Technical Note

Project: Land at Toton West, Broxtowe

Subject: Review of Transport Submissions

Client:	Broxtowe Borough Council		
Project No:	10471	Version:	B
Document Ref:	TN-01	Author:	JW
Date:	16/06/2026	Approved:	CS

Figure 2: Amendments to Existing Pedestrian Crossing

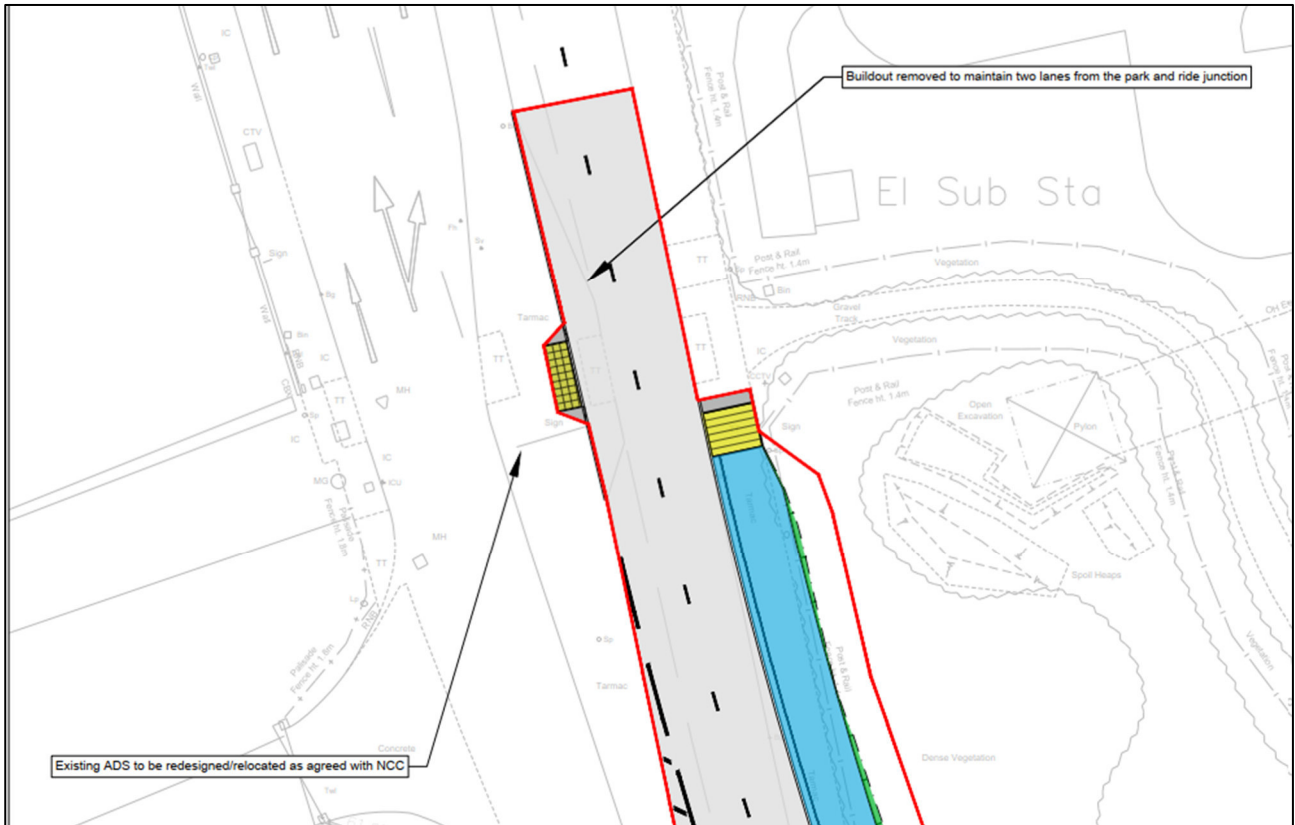
- 3.1.6 At the northern end of the design, there is an existing uncontrolled pedestrian crossing. Stapleford Lane is proposed to be widened in this location, meaning pedestrians are required to cross two lanes rather than one.

| 3.1.7 | Increasing the number of lanes to be crossed will make the crossing more difficult for pedestrians to use. However, this must be balanced against the new signalised crossing that will be provided at the site access. |

Figure 4: Extract - Proposed Mitigation Scheme

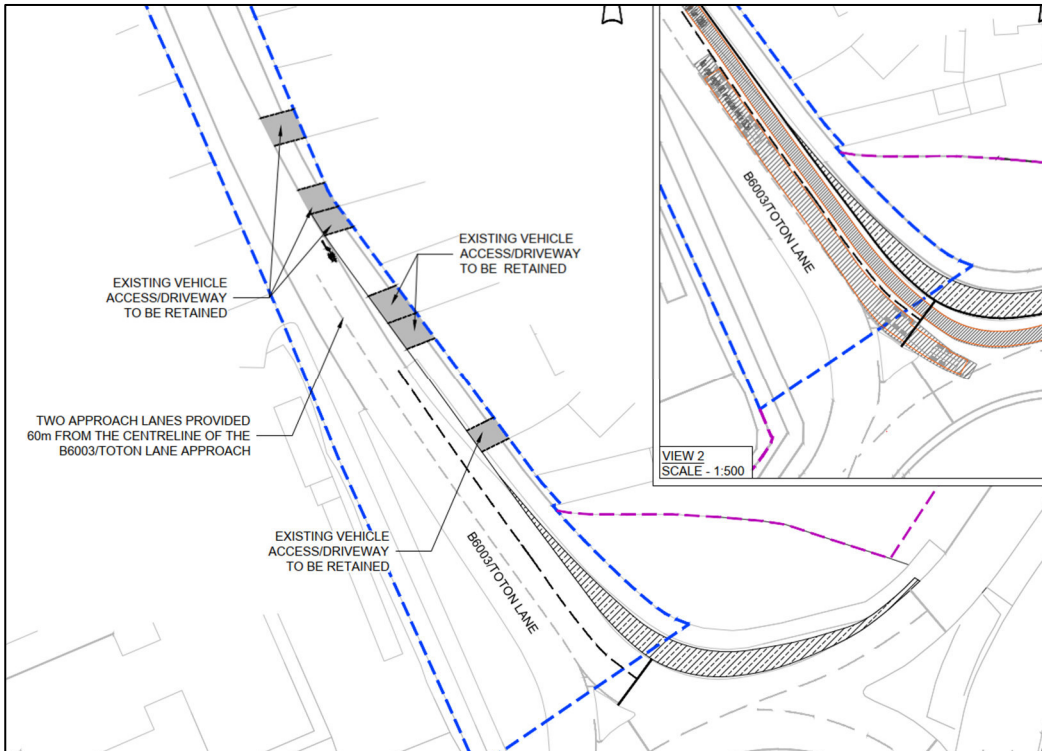
- 5.6.4 The widening narrows a shared footway/cycleway/verge to provide additional carriageway space. As the design is based on OS mapping, and with no scale bar on the drawing, it is difficult to tell what the remaining minimum width will be. A typical minimum width alongside a 40mph road would be 3m plus a 0.5m buffer.

- 5.6.5 Existing driveway access will be retained, although the footway crossover width will be reduced, which may increase the gradient of the footway. There are numerous items of street furniture that would need to be relocated. This will be a matter for the developer to resolve during detailed design.

- 5.6.6 Overall the effect of the scheme will be to increase the throughput of the nearside lane, which in turn allows more green time to be given to the circulatory carriageway and improves the overall efficiency of the junction, to a small extent.

- 5.6.7 An alternative scheme is proposed for the event that the 'sensitivity' site comes forward, which would provide a further widening within the circulatory diameter.

Figure 5: Extract - Mitigation Scheme

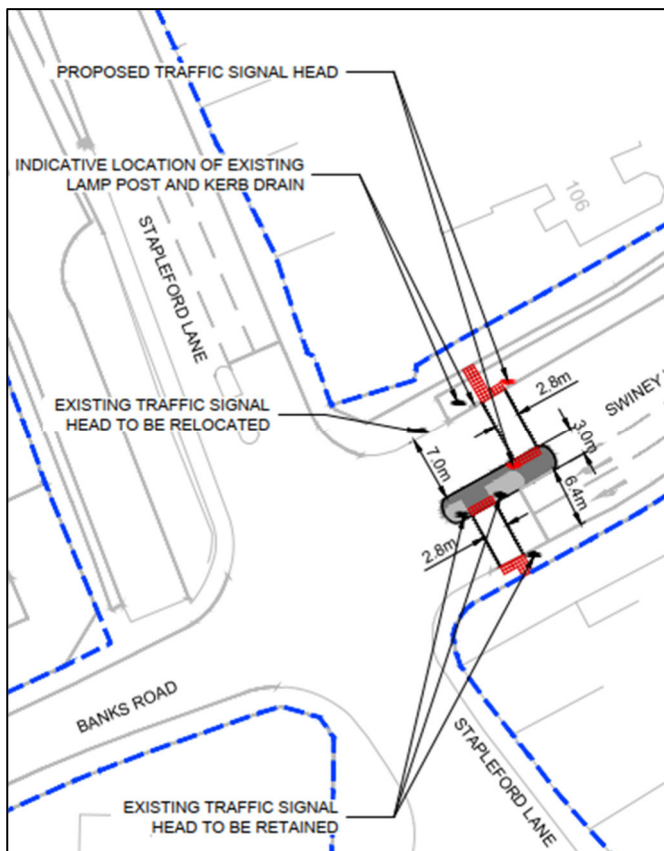
- 5.8.4 In the existing layout the eastern (Swiney Way) crossing is long at around 17 metres. This results in a long 'intergreen' period after the pedestrian crossing is called (17 seconds), to allow pedestrians to finish crossing the road before traffic is released.
- 5.8.5 The mitigation scheme proposes to provide a staggered pedestrian crossing, so that pedestrians cross in two stages.

- 5.8.6 The overall effect of this change is that the intergreen period following the pedestrian crossing can be reduced from 17 seconds to 10 seconds. There is a smaller disbenefit as part of the crossing runs in the traffic stage and requires a longer intergreen by two seconds.
- 5.8.7 The overall effect is that when the pedestrian crossing is used, five seconds additional traffic can be given to vehicle traffic.
- 5.8.8 As noted, the capacity is sensitive to how often the crossing is called which has not been recorded. However, if the crossing is called more frequently, then the relative benefit of the scheme would increase.

- 5.8.9 The results indicate the scheme would provide a capacity improvement at the junction, and again there is no allowance for mode shift.
